Subject: Pressure fryer lid handle roller inspection change

Date: 03/14/24 Region: Global

Model Effected: PXE100, PFE 590, 591 and 592, PFG 690, 691 and 692

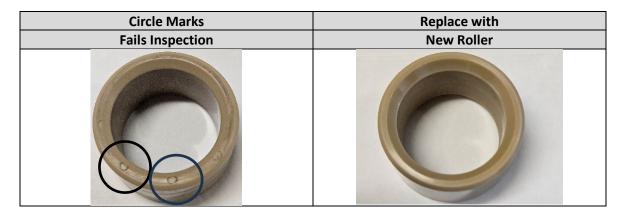
Previously, our inspection criteria involved identifying cracks, flat spots, or deep grooves on the rollers. If any of these issues were found, the roller would fail inspection and require replacement.

Now, we have incorporated an additional failure mode into the inspection procedure. Upon removing and properly cleaning the roller for inspection, it is crucial to carefully examine each outer edge. If any circle marks are observed, the roller fails inspection and must be replaced.

IMPORTANT: Perform this additional inspection criteria during routine inspections. This is NOT a proactive part replacement request.

Once the rollers are removed from the pressure fryer's lid handle, look for circle marks.
